PLANNING COMMISSION AGENDA
COEUR D'ALENE PUBLIC LIBRARY
LOWER LEVEL, COMMUNITY ROOM
702 E. FRONT AVENUE

MAY 12, 2015

1. Applicant: Lake Forest, LLC
Location: 1555 W. Hanley Avenue
Request: A proposed 66-lot preliminary plat "Lake Forest West 1st Addition
QUASI-JUDICIAL, (S-1-14m)

FROM: SEAN E. HOLM, PLANNER
DATE: MAY 12, 2015
SUBJECT: S-1-14.m – A 66 LOT PROPOSED PRELIMINARY PLAT
SUBDIVISION KNOWN AS “LAKE FOREST WEST 1st
ADDITION”
LOCATION: +/- 13.97 ACRES NEAR THE NORTHEAST CORNER OF
HANLEY AVENUE AND RAMSEY ROAD

ILLUSTRATED DEVIATIONS: Lot Frontage and Double Frontage Lots

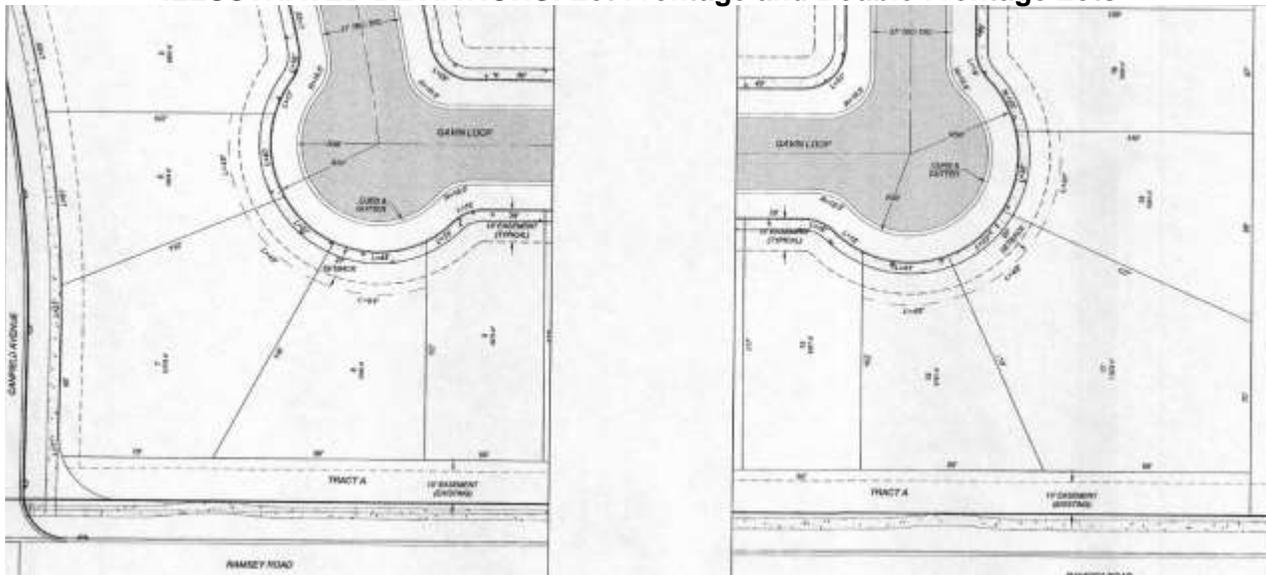
There are two (2) requested deviations for this request. They are the same deviations requested in the original Lake Forest West preliminary plat approval:

1. Lot Frontage

- Lot frontages on lots that are situated in “knuckles” (eyebrow cul-de-sacs) of the development require a deviation to allow reduced frontage from the minimum of fifty feet (50’). Six lots fall into this category. They range from thirty-one feet (31’) to forty-four feet (44’) in linear frontage, shown below.

2. Double Frontage Lots

- Double frontage lots, buffers, and the newly adopted subdivision code are discussed in finding #B7C above, as well as illustrated below.

8. Joint driveway approaches will be required for all of the lots situated on the “knuckles”. Driveway separation for the individual lots can begin on the “backside” of the installed sidewalk.
